March 24, 2016

**Re: Red and Bonita Mine Bulkhead Closure Evaluation; D&A Job No. CG-0628.001.00**

This letter is in response to a request by the US Environmental Protection Agency (EPA) to comment on the Colorado Division of Reclamation, Mining, and Safety (DRMS) report "*Design Basis for Water Impounding Concrete Bulkhead, Red and Bonita Mine, San Juan County Colorado*" dated November 4, 2015. Specifically, we have been asked to comment on the potential impacts of closing the Red and Bonita Bulkhead valve (installed in September 2015) on other adits, bulkheads, and streams in the upper Cement Creek area. To aid in our evaluation, we reviewed mapping and 3D modeling conducted by DRMS and conducted a literature review of geologic maps, papers, and reports on the hydrology and the existing bulkheads. This letter is a revision of our previous report, dated February 17, 2016, and incorporates additional flow data along with text corrections.

<b>AMERICAN TUNNEL AND MINES</b>	
<b>Adit Flows in Upper Cement Creek</b>	
<b>DEERE &amp; AULT</b>	<b>FIGURE NO.</b>
<b>CONSULTANTS, INC.</b>	<b>3</b>
<b>DATE:</b> 3-24-16	<b>SCALE:</b> AS NOTED

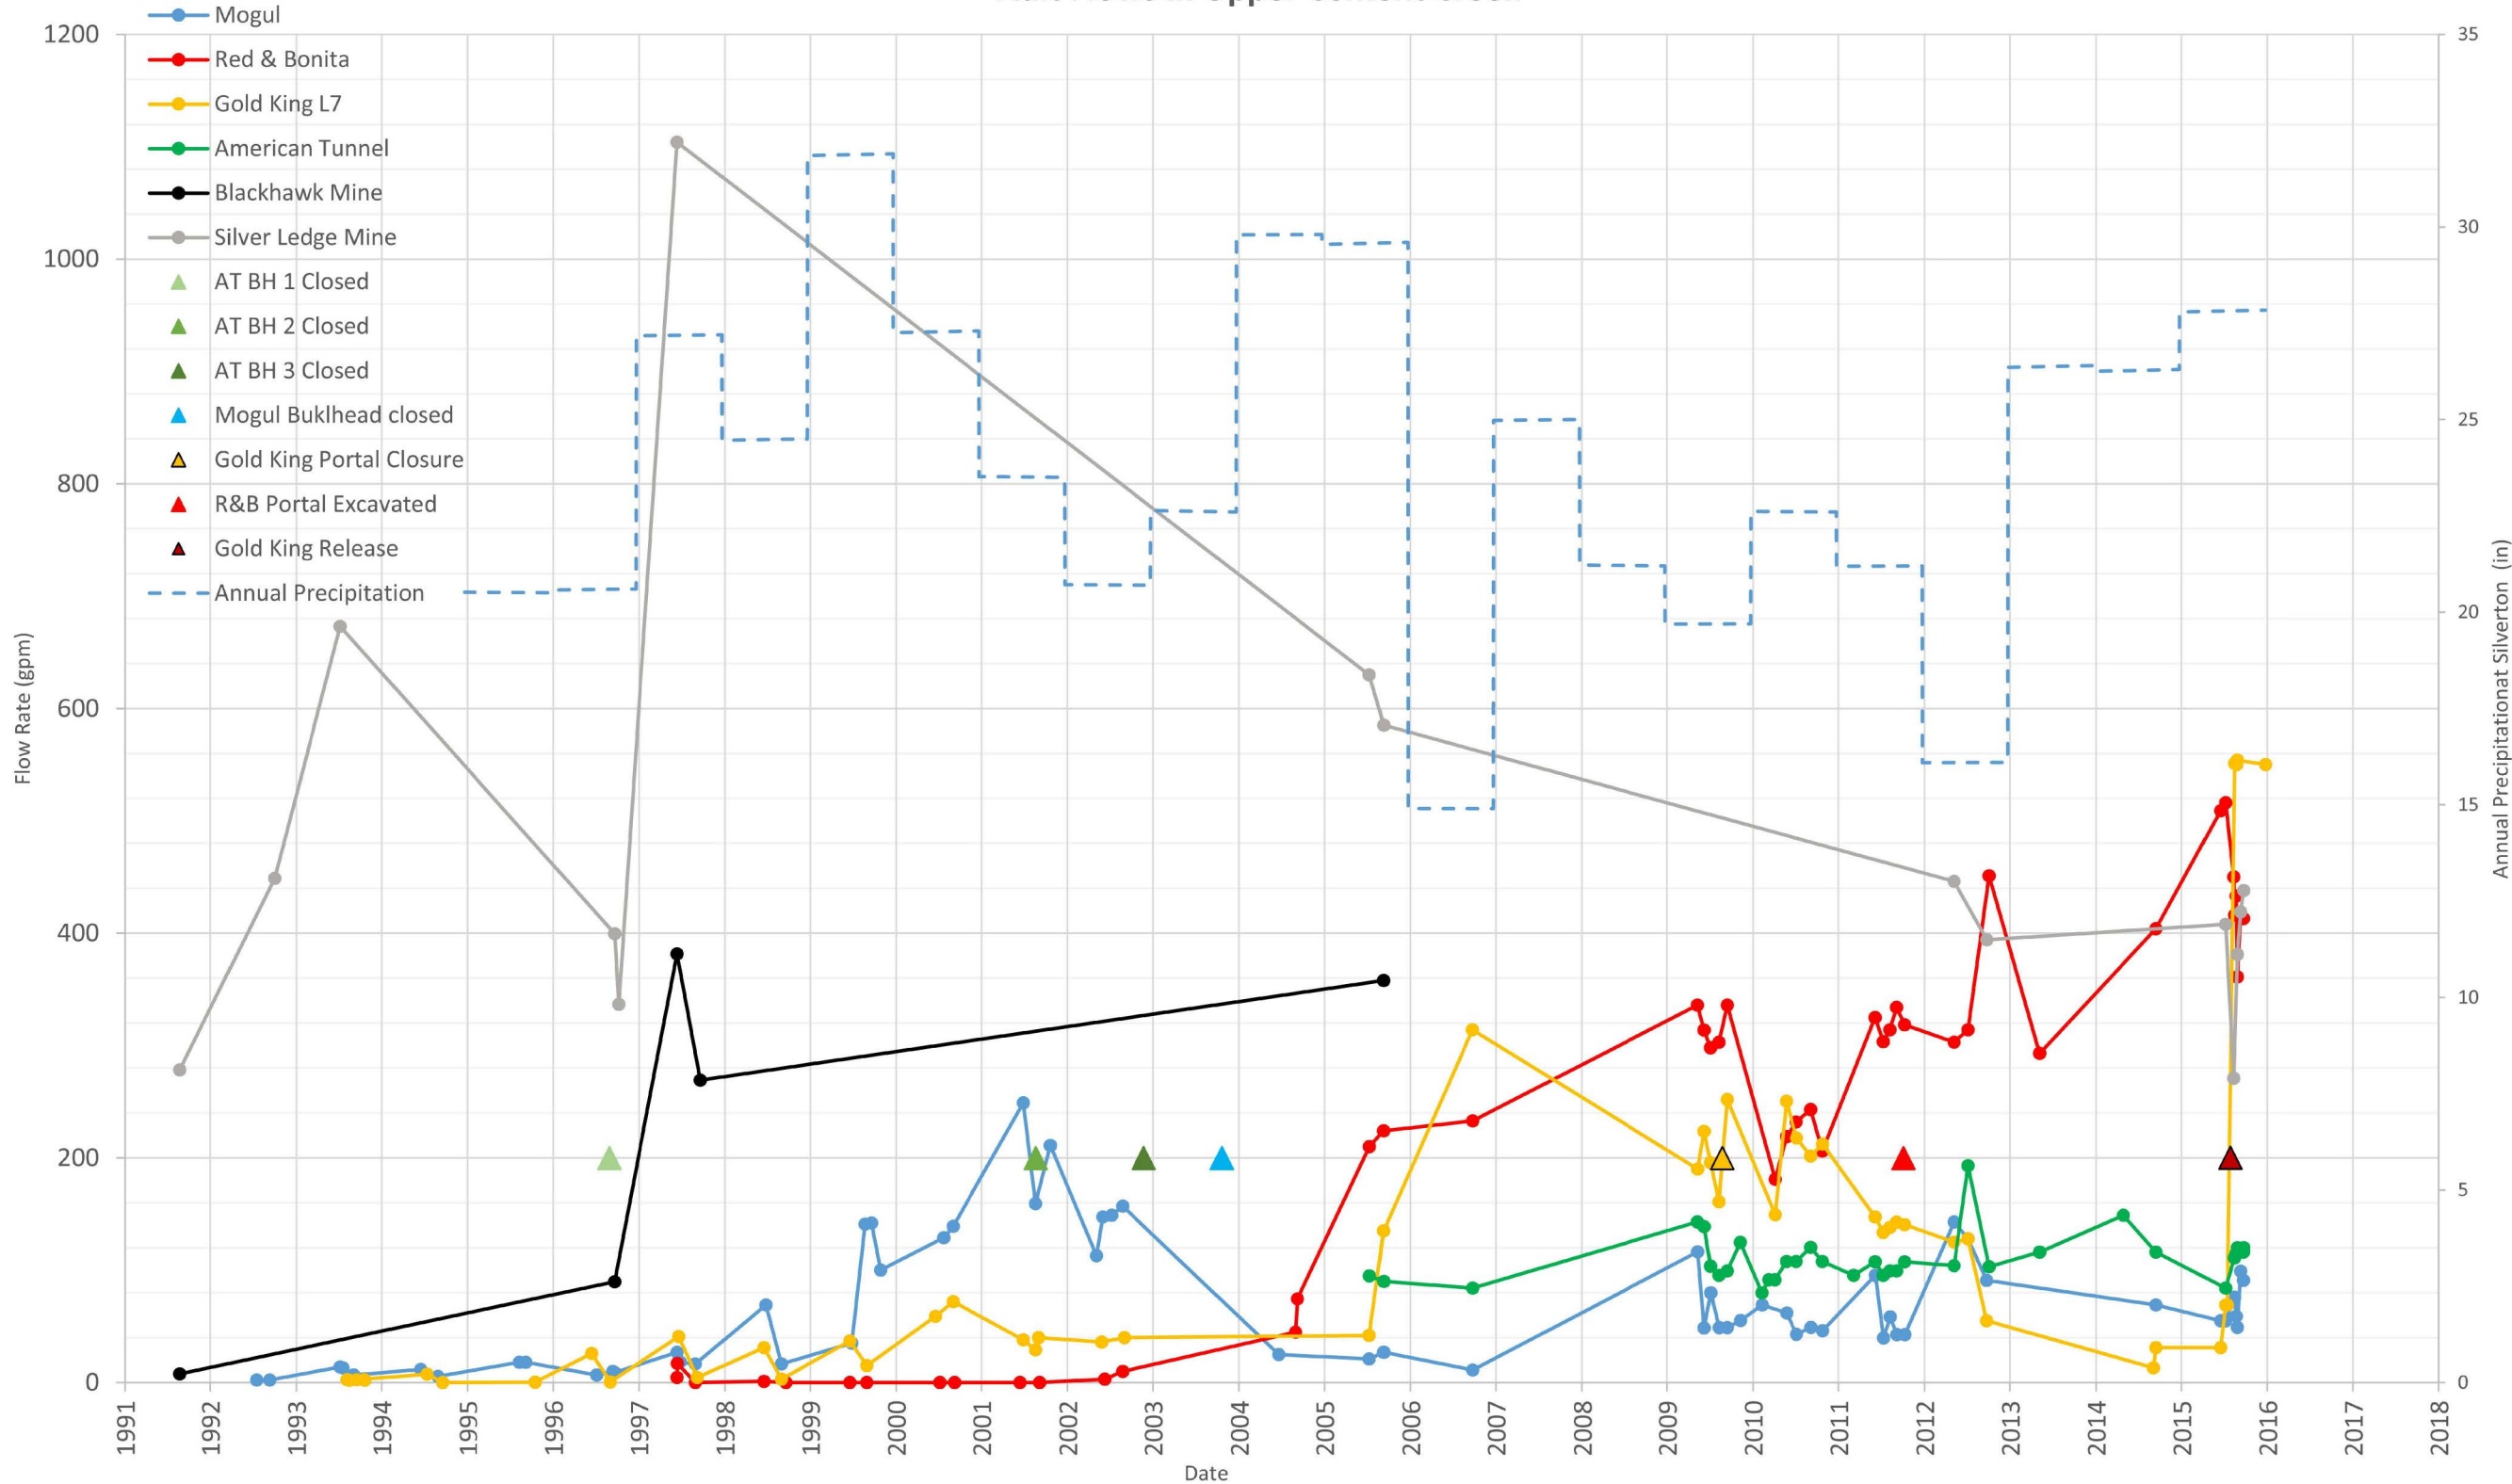
More frequent tracking of flow rates in the area began in the 1990s. **Figure 3** graphs the flow rates from various mines shown on **Figure 1**. In addition, it tracks flow from two abandoned mines south of the American Tunnel, the Blackhawk, and Silver Ledge (also known as Natalie/Occidental). To our knowledge, no flows have been observed or measured from the Adams Mine, Lead Carbonate Mine, or Adit 268-21. **Figure 3** also shows the annual precipitation in the area (1995 through 2015).

The data comes from the NOAA Silverton Meteorological Station. For quick reference, **Figure 3** shows the dates when various bulkheads in the area were shut.

In 1997, the summer after the American Tunnel Bulkhead 1 was closed, flows from both the Silver Ledge and Blackhawk mine increased dramatically. While this suggests some connection, it is actually unlikely given the distance from the Sunnyside Mine, the fact that the Sunnyside Mine pool elevation was lower than the Blackhawk in 1997, and that the flows from Silver Ledge decreased to pre-bulkhead rates by 2012 (average flows from 1991 to 96 were 427 gpm while average flows from 2012 to 15 were 407 gpm). Instead, both the Blackhawk and Silver Ledge Mine flows seem to be tied to precipitation and the associated surface water, not the Sunnyside mine pool.

In 1999, as the Sunnyside Mine pool reached the F Level Brenneman-Mogul bulkheads, discharge from the Mogul Mine portal greatly increased from 17 gpm in September 1998 to 141 gpm in September 1999. Flows then ranged from 100 to 249 gpm until the Mogul Bulkhead was constructed in November 2003. At that point flows decreased to an average of 22 gpm.

None of the adits showed a significant immediate response to the closing the American Tunnel Bulkheads 2 and 3. The Red and Bonita increased flows from 10 gpm in 2002 to 74 gpm in 2004, likely as a time lagged response to bulkhead closures. Between 2005 and 2015, flows from the American Tunnel and Mogul Mine remained relatively steady.
